STAFF RECOMMENDATION

NCPC File No. 6769

H.D. COOKE ELEMENTARY SCHOOL MODERNIZATION AND EXPANSION

November 29, 2007

SITE PLAN

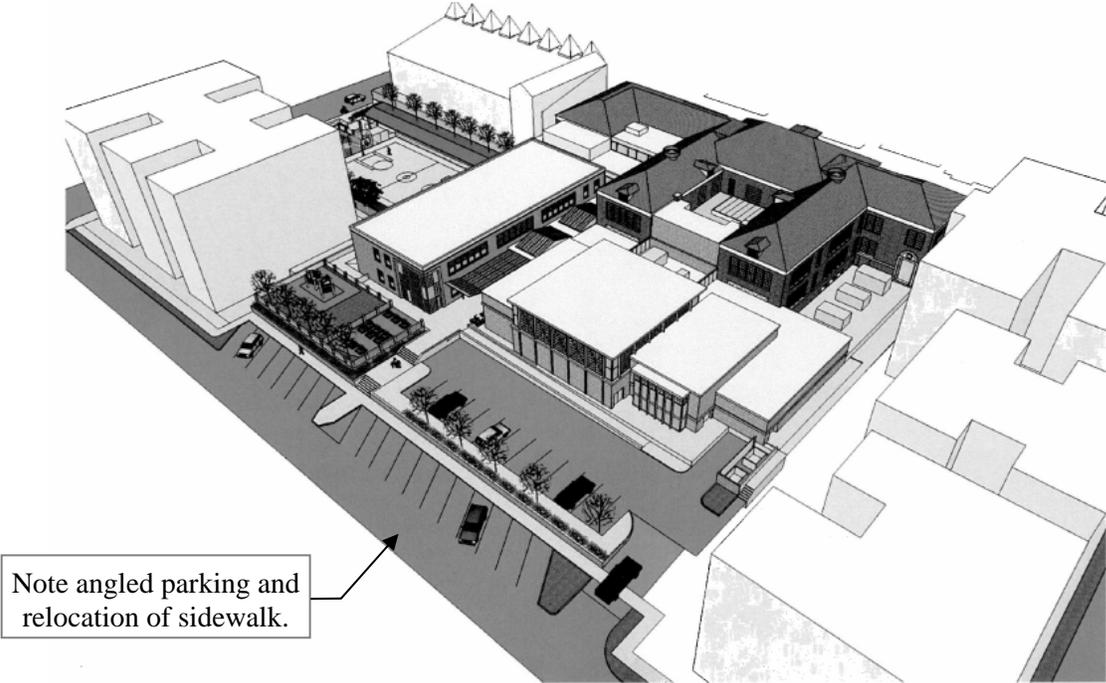
However, Staff concurred with the DC-SHPO's analysis that the proposed relocation of the sidewalk and angled parking area along Mozart Place were inconsistent with the urban character of the neighborhood and should be modified. Staff recommended that the applicant revise the final streetscape and parking area design along Mozart that maintains the urban characteristics of the site by retaining the existing sidewalk location and providing landscaping/screening between the sidewalk and the new parking area. Final plans should also comply with DDOT streetscape design and material standards.

The SHPO did note concerns regarding the relocation of the sidewalk and the creation of angled parking between the public space and the school property, in effect "eroding the street wall" taking a suburban approach that is inconsistent with the surrounding urban neighborhood. NCPC staff concurs with the DC-SHPO determination as well as their concerns regarding urban streetscape development.

As a result of consultation during the project review period with NCPC, DDOT, and other District agencies, the applicant revised the parking area design to remove parking areas from public space along Mozart Place. Staff finds that the revised design, which accommodates parking for 25 vehicles, to be a more compatible solution that relates better to the urban streetscape. Staff recommends that additional landscaping be incorporated into the area along Mozart Place, adjacent to the sidewalk, to visually screen the parking area.
